TECHNICAL RESPONSE TO HCC HIGHWAYS COMMENTS

Ridge and Partners have been commissioned to respond to the Road Safety Audit undertaken by Fenley (March 2026) as part of the S278 Technical Approval Process.

Road Safety Audit Report

Proposed Continuation of Coldharbour Farm Road Emsworth

DRAWN BY: AK CHECKED BY: APPROVED BY:

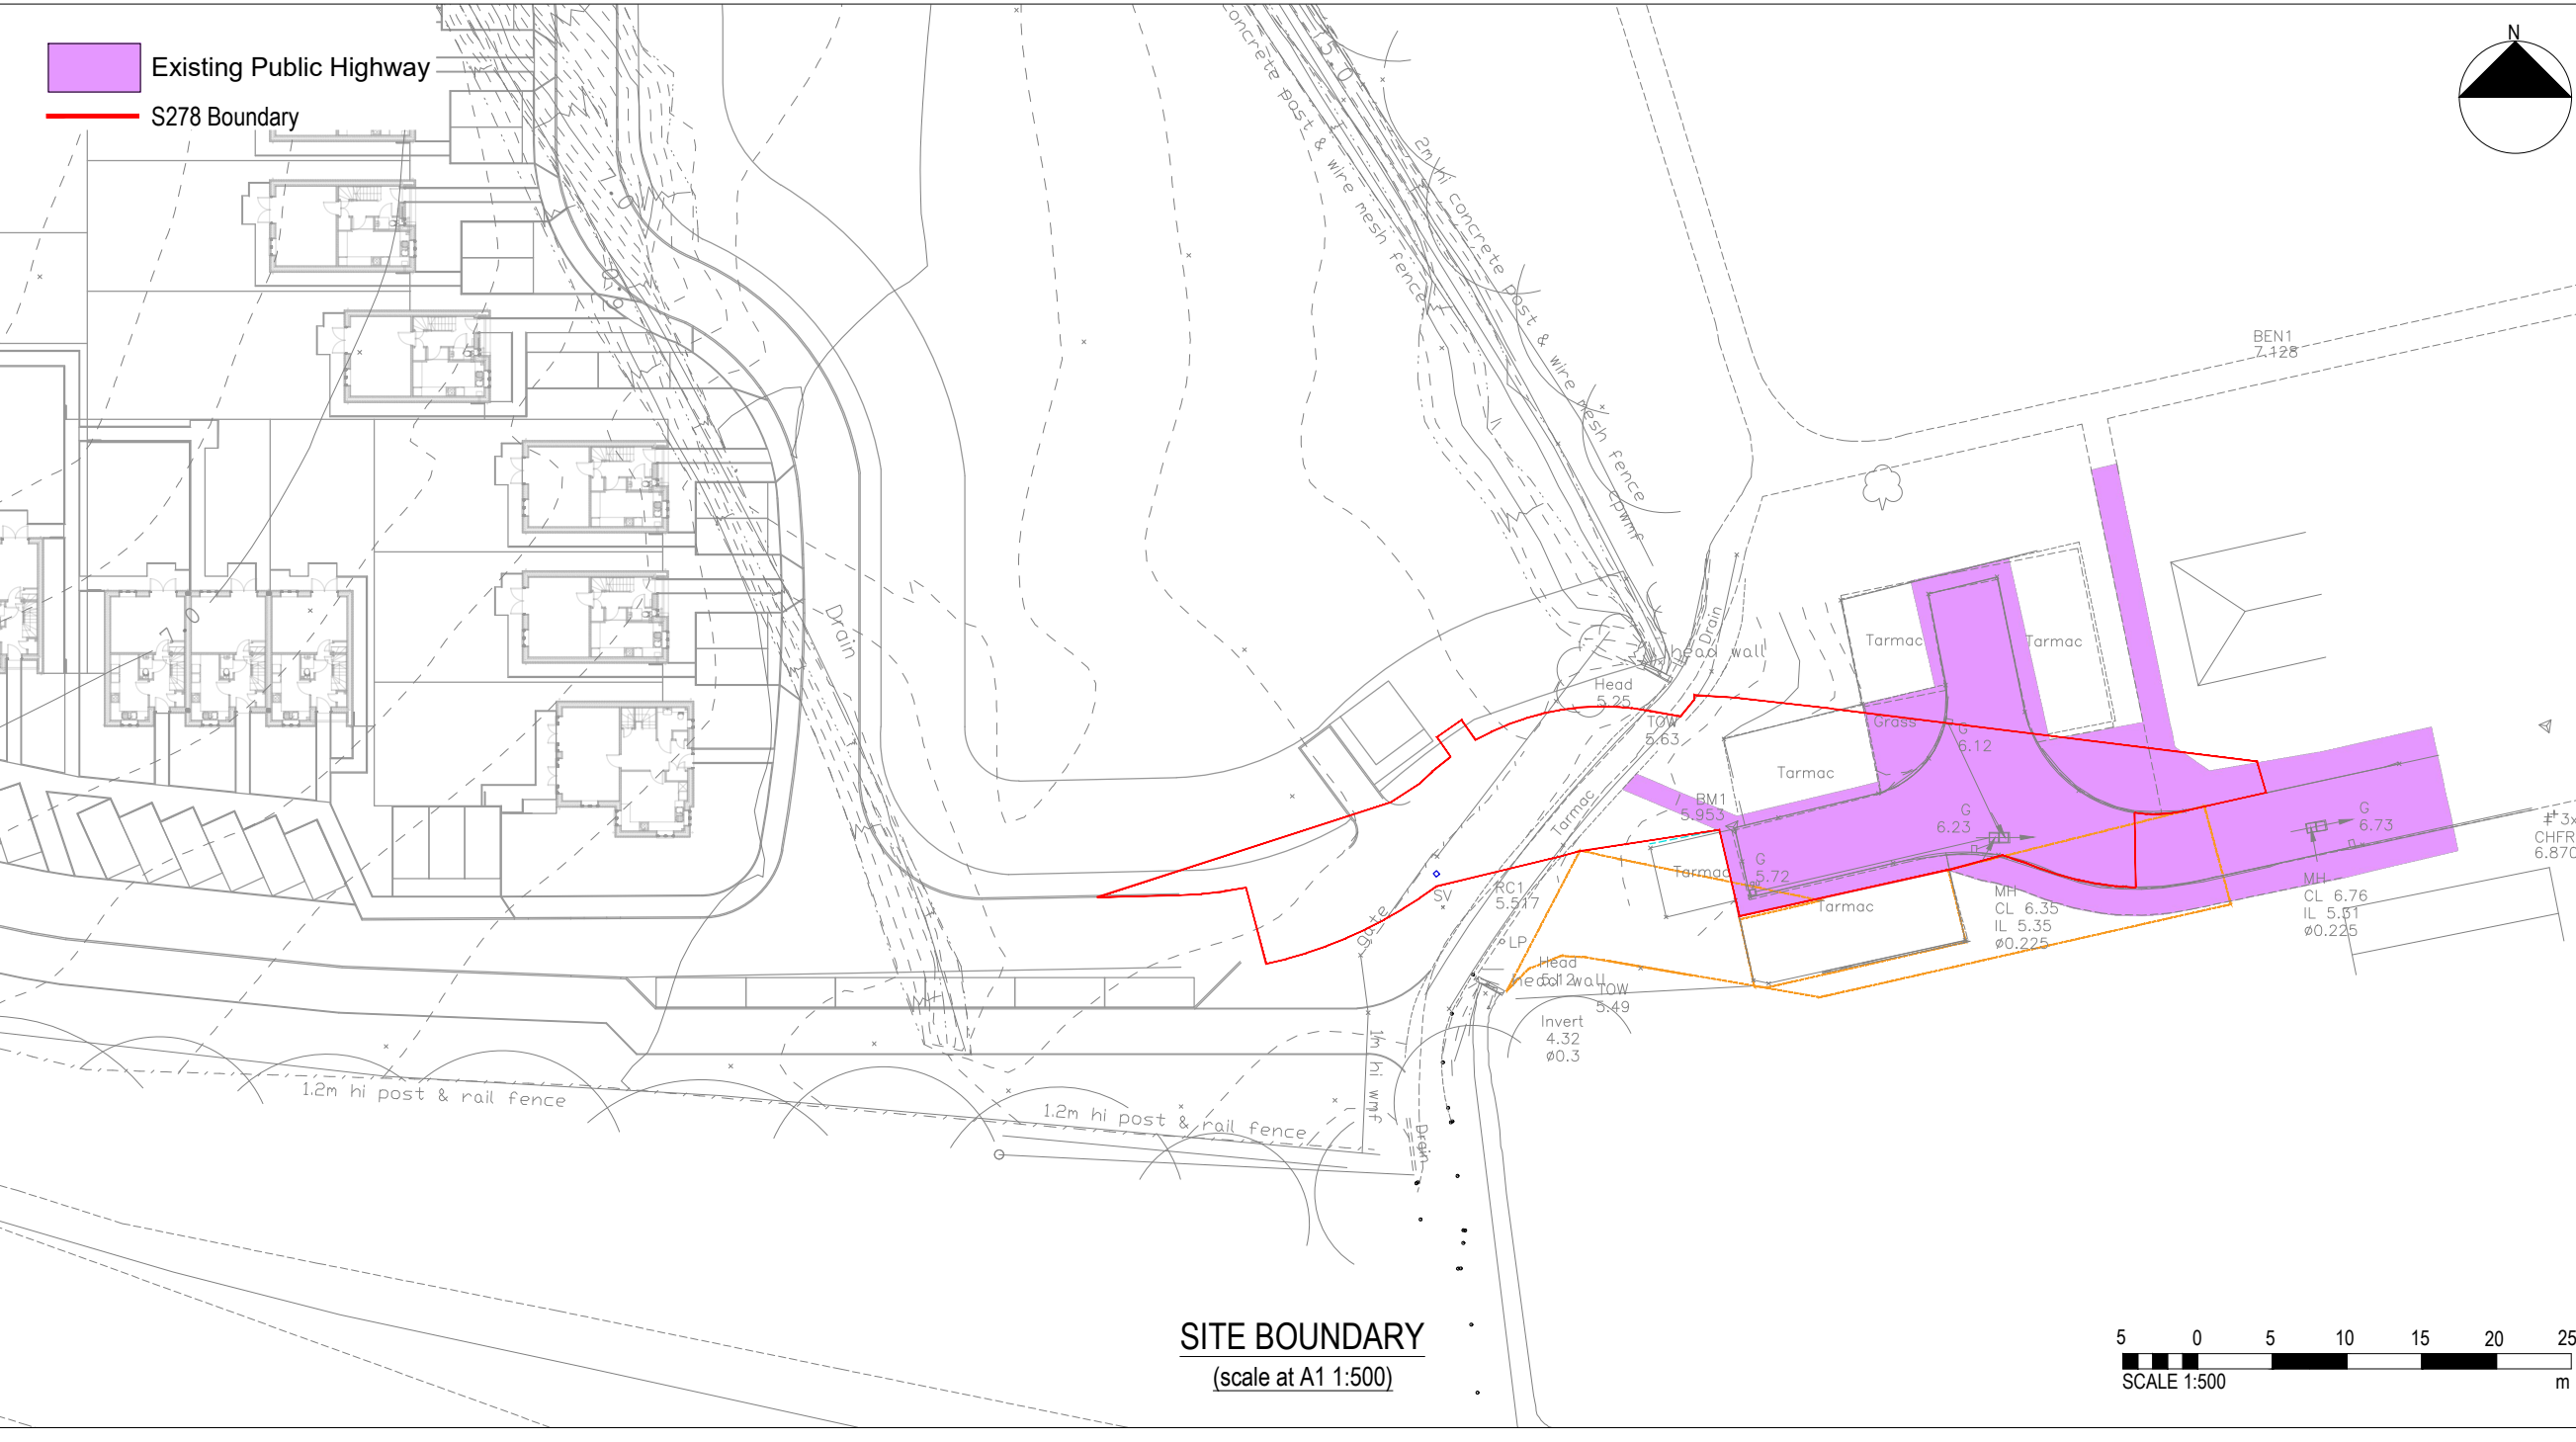
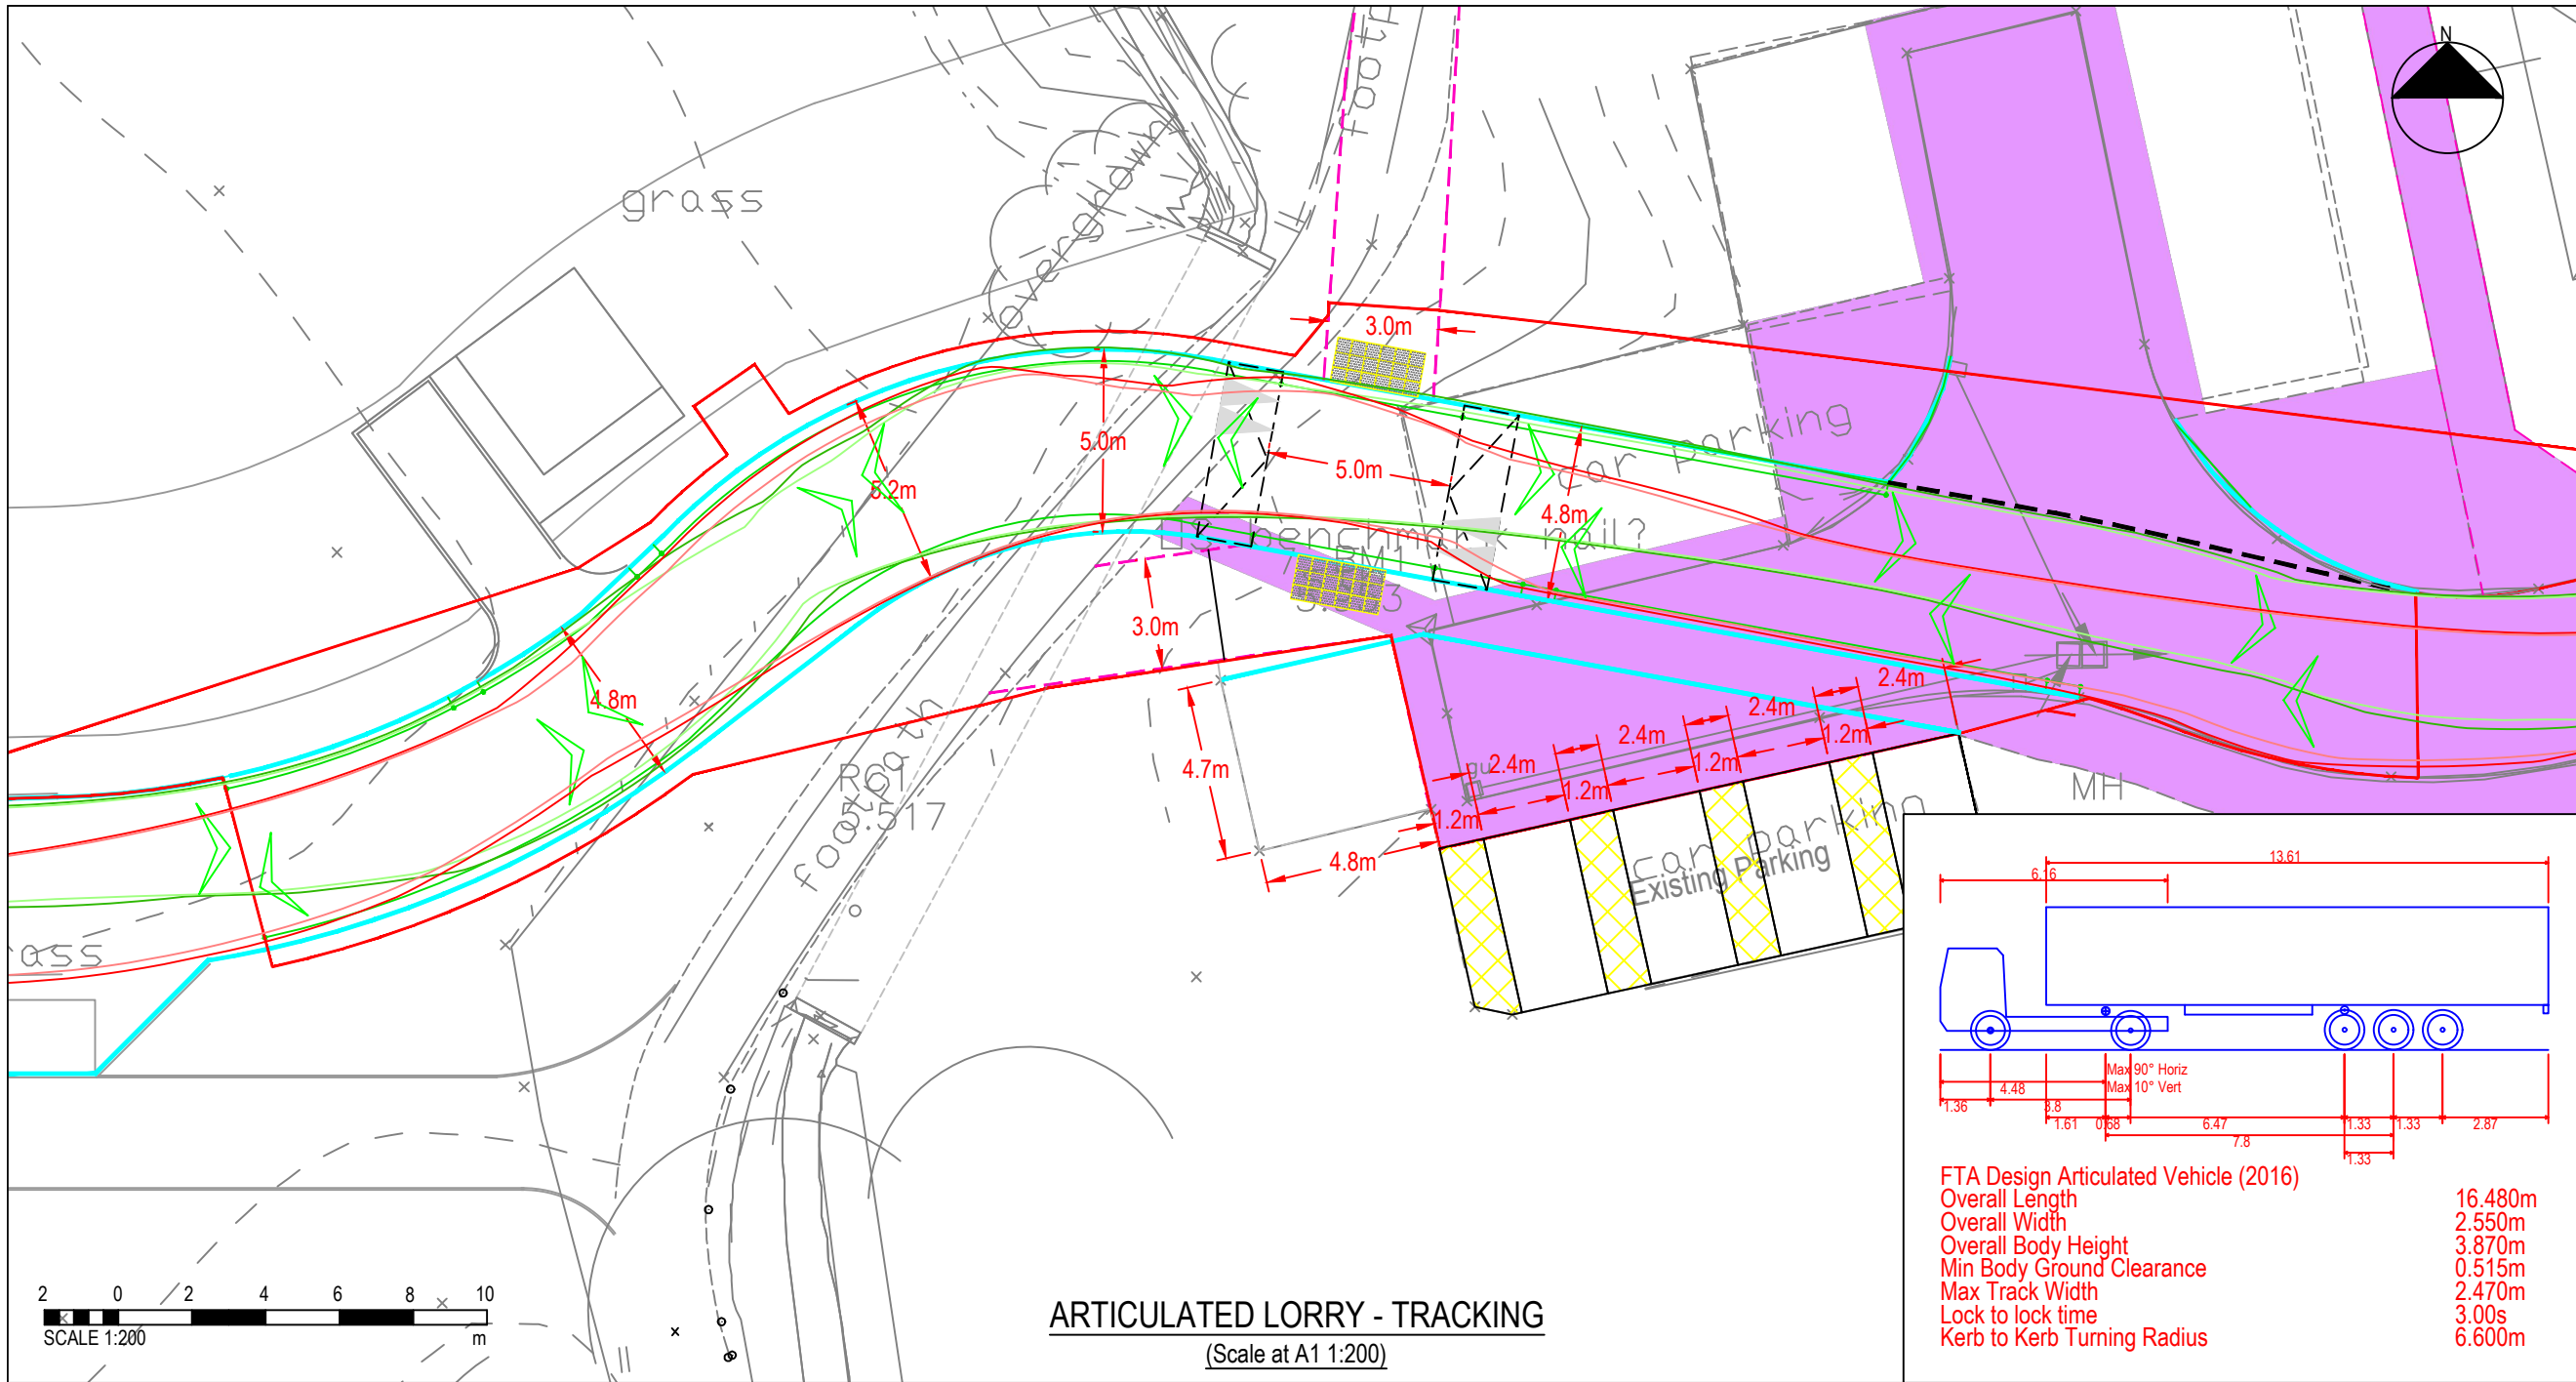
B.4.1 - Cyclists are likely to continue without giving way to traffic. It is recommended that an appropriate level of visibility is achievable.

B.4.2 - Non-motorised users at and on approach to the uncontrolled crossing may not be clearly visible during the hours of darkness. It is recommended that visibility is achievable to the tangent and that the proposed crossing point is illuminated adequately with a column provided immediately to the west of the crossing point as previously proposed.

Suitable visibility splays for cyclists are as shown on Drawing 23339-JUBB-XX-XX-DR-X-000100 REV C13. In dashed orange. With regards to lighting, this has been confirmed as suitable by the lighting designer.

Suitable visibility splays for pedestrians are as shown on Drawing 23339-JUBB-XX-XX-DR-X-000100 REV C13. In dashed yellow. With regards to lighting, this has been confirmed as suitable by the lighting designer.
